SERVICE BULLETIN

DATE: October 10, 2014 Service Bulletin No. 614A
(Supersedes Service Bulletin No. 614)
Engineering Aspects are
FAA Approved

SUBJECT: Exhaust System Inspection and Turbocharger Mounting Bracket Replacement
MODELS AFFECTED: Lycoming Engine Model TIO-540-AJ1A with a Serial Number Identified in Table 1 or any TIO-540-AJ1A with a Turbocharger Mounting Bracket Purchased as a Spare between April 5, 2012 and May 29, 2014

Figure 3
TIO-540-AJ1A Turbocharged Exhaust System

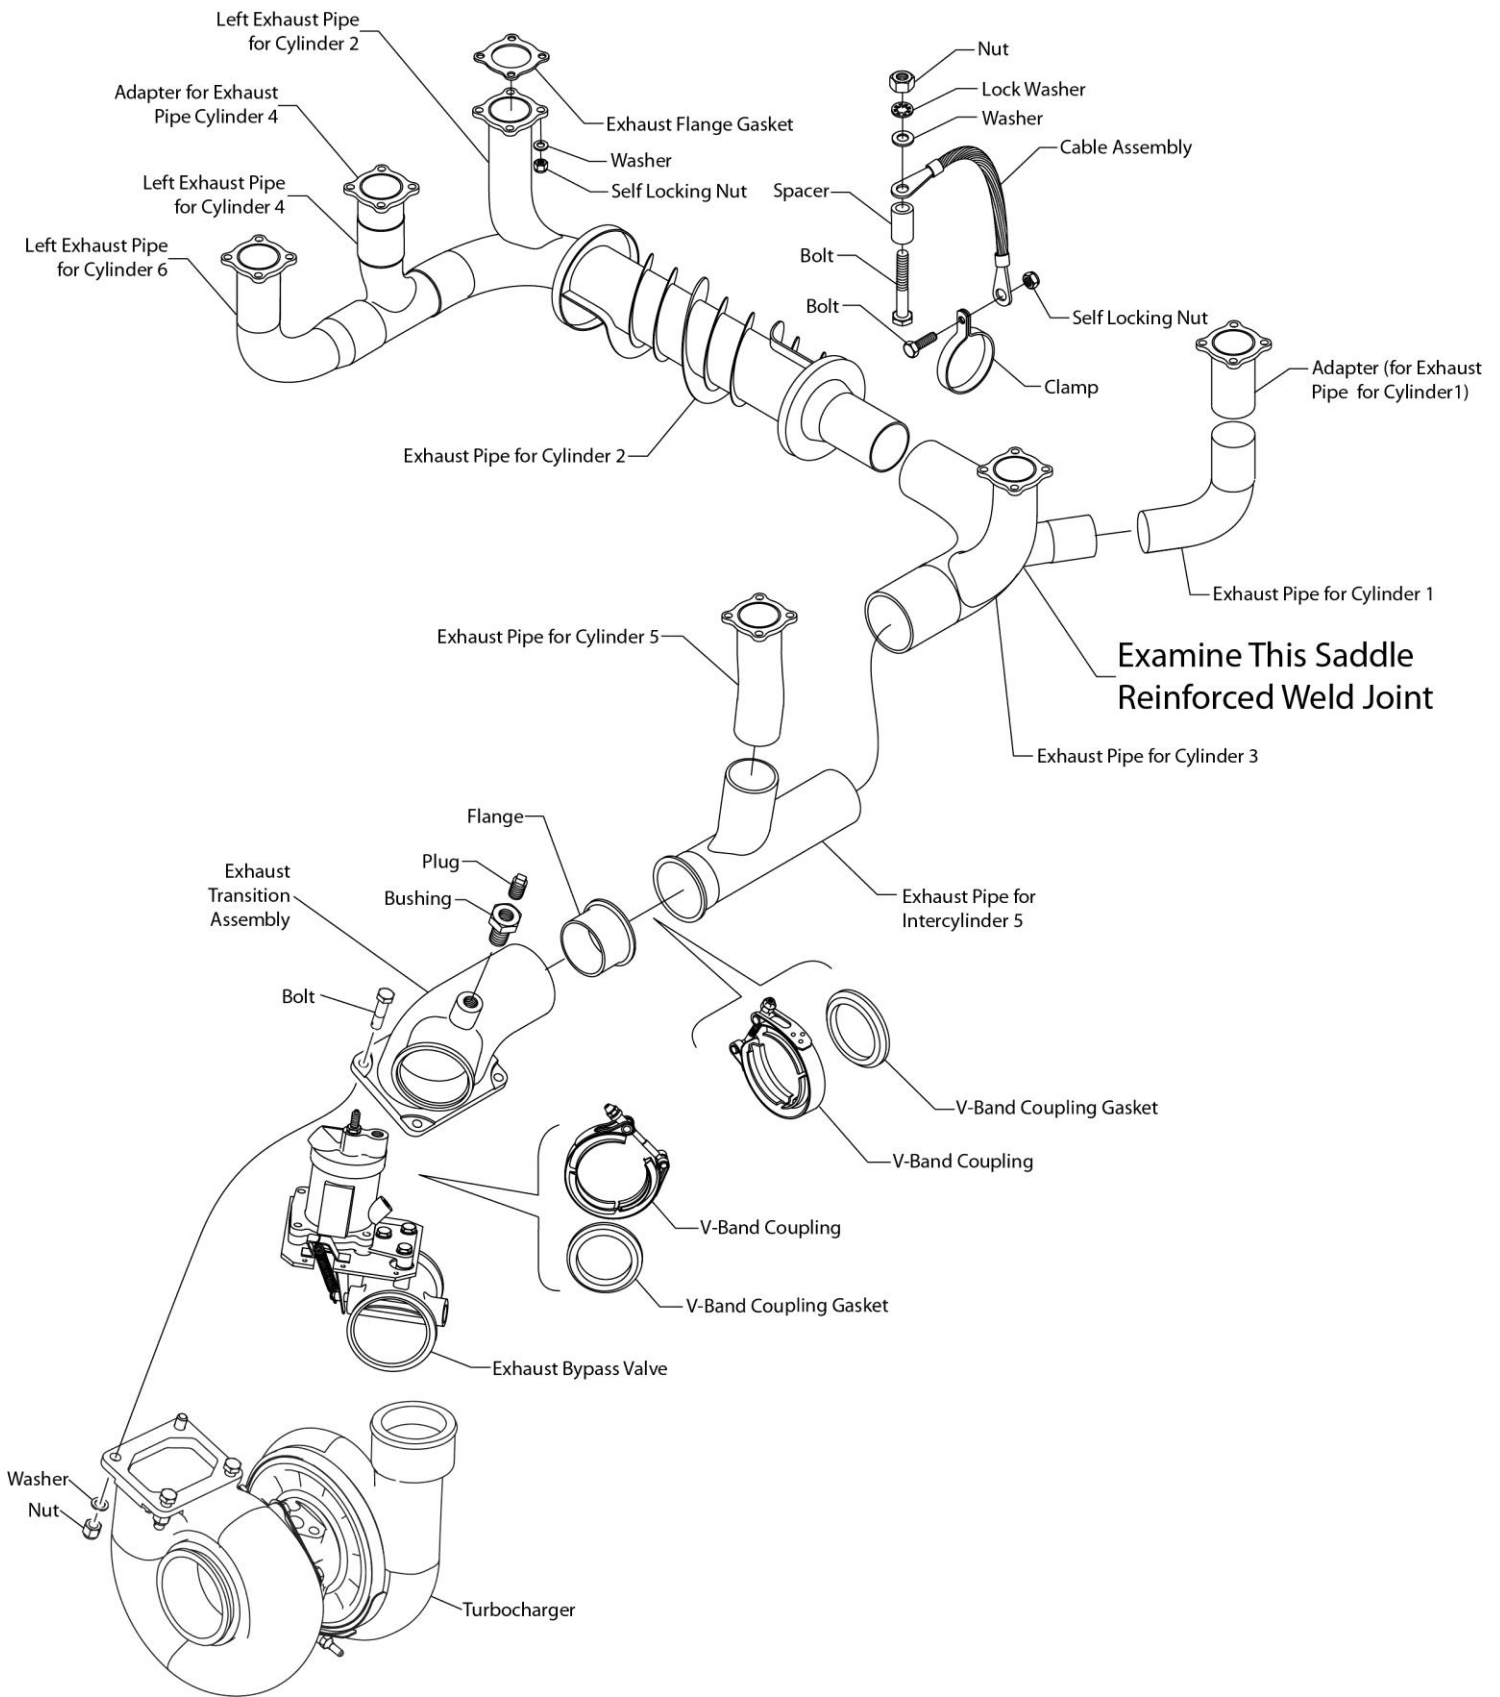
1. Apply a uniform coating of Loctite® C5-A® anti-seize compound or equivalent to the slip joint mating surfaces (Figure 3) of the exhaust pipes.
2. Assemble the exhaust pipes at the slip joints and make sure there is no binding of the joined parts. If any binding or tightness is found, replace the exhaust pipes.
3. Apply a uniform coat of Loctite® C5-A® anti-seize compound or equivalent to the stud (Figure 6) on the exhaust transition assembly.

Figure 6
Turbocharger

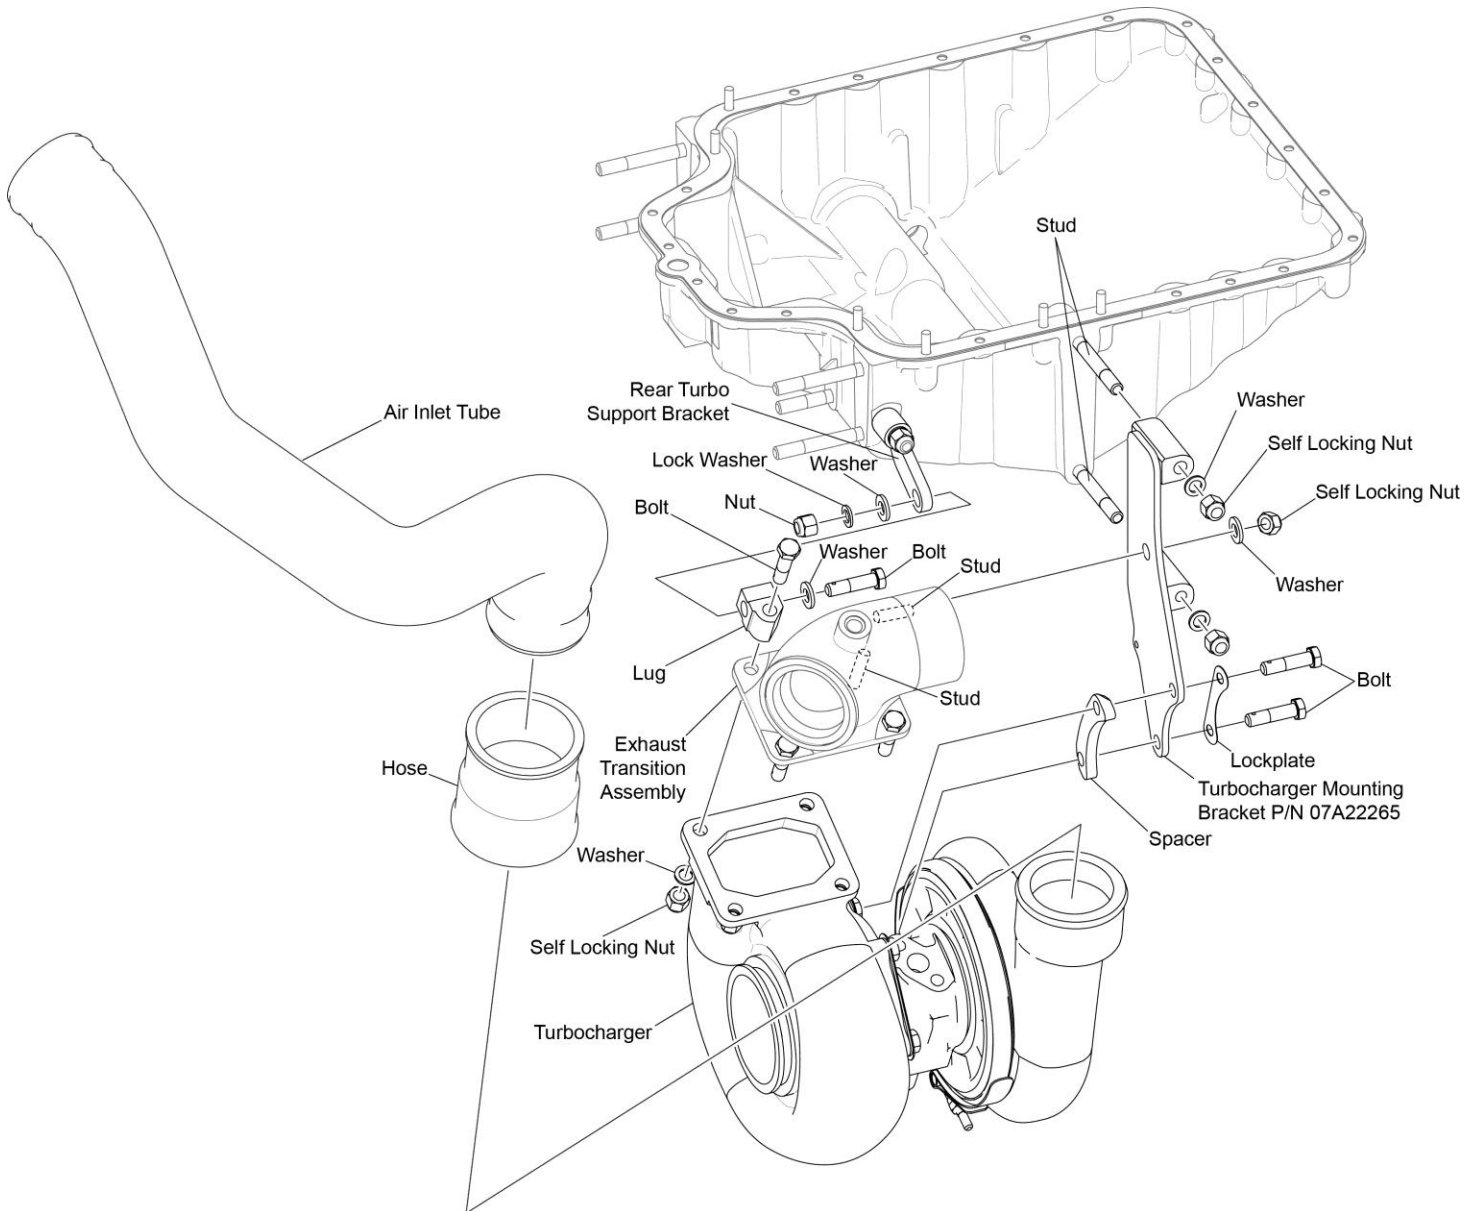
18. Bend down the tabs of the lock plate (Figure 6).
19. Remove the two bolts, spacer, and lockplate that attach the turbocharger mounting bracket to the turbocharger (Figure 6). Discard the lockplate. Keep the spacer for reassembly.

21. Remove the turbocharger mounting bracket and send this bracket to Lycoming Engines to receive a replacement bracket as per warranty terms in this Service Bulletin. Refer to the replacement parts list in the “Warranty Instructions” section of this Service Bulletin.
22. Remove the three bolts, three self-locking nuts and three washers that attach the exhaust transition assembly to the turbocharger (Figure 6). Discard the self-locking nuts.

7. Install the new turbocharger mounting bracket P/N 07A22265 on the turbocharger (Figure 6) and the stud on the exhaust transition assembly with the two bolts, spacer, and new lockplate. Torque the two bolts to 160 to 190 in.-lb. (18 to 21 Nm). Bend the tabs (Figure 6) of the lockplate into place.

- B. Torque the nuts that attach the new turbocharger mounting bracket (Figure 6) to the oil sump to 30 ft.-lbs. (40.7 Nm).
 - C. Torque the self-locking nuts that attach the exhaust transition assembly (Figure 6) to the turbocharger to 30 ft.-lbs. (40.7 Nm).

- D. Torque the nut that attaches the exhaust transition assembly to the turbocharger mounting bracket (Figure 6) to 30 ft.-lbs. (40.7 Nm).
 - E. Torque the nuts that attach the exhaust pipes to the cylinders (Figure 3) to 96 in.-lb. (11 Nm) -on all cylinders.

Figure 7
Turbo Oil Drain Tank and Support Bracket

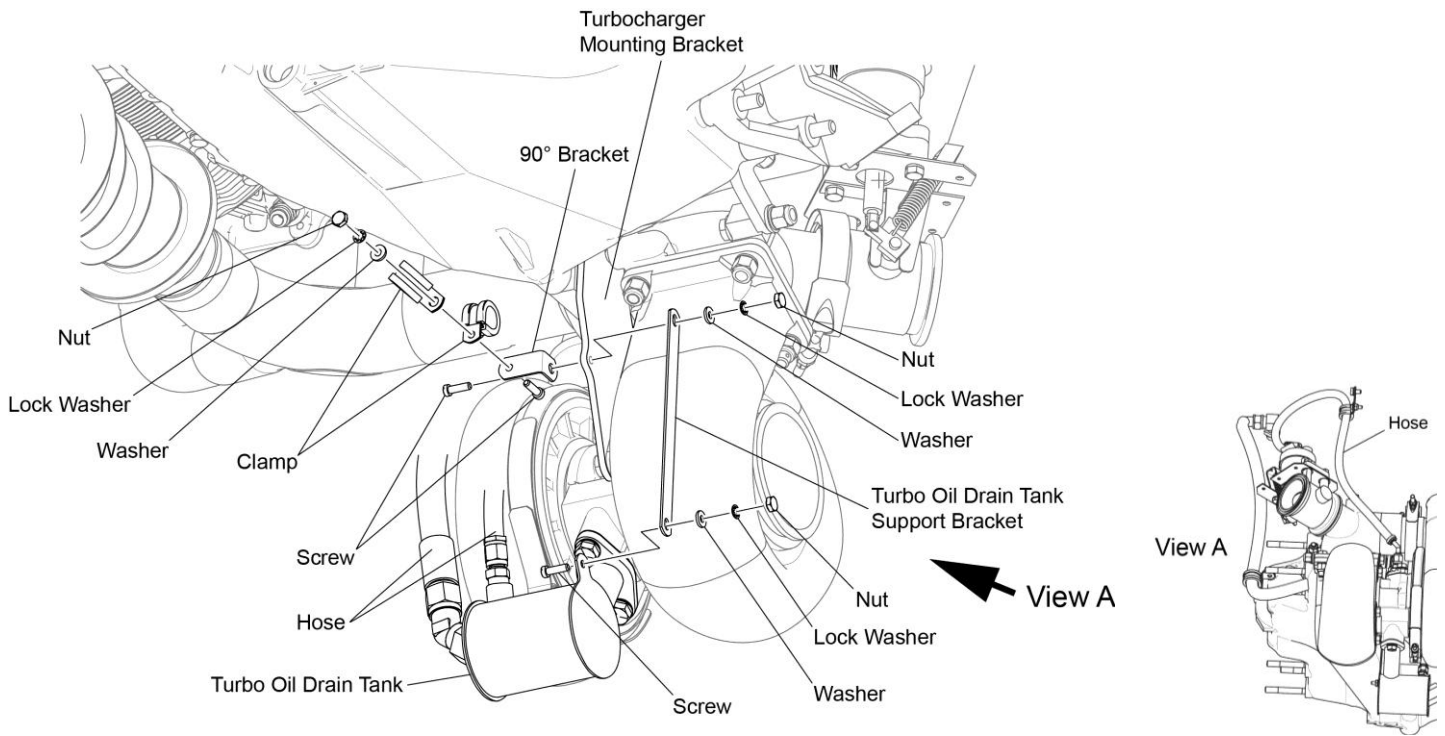
11. Install the screw, washer, and new self-locking nut that attaches the turbocharger oil drain tank support bracket, and 90° bracket with the clamps attached, to the turbocharger mounting bracket (Figure 7). Torque the clamps to 49 in.-lb. (5.5 Nm).

Figure 9
Saddle

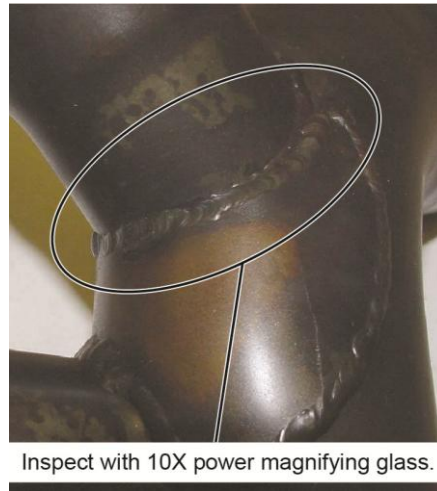
1. Use a 10x power magnifying glass to examine the weld joints of the exhaust pipe for cylinder #3 (Figure 3). Closely examine the saddle reinforced weld joint (Figures 8 and 9). If any cracks or damage are found, replace the exhaust pipe.
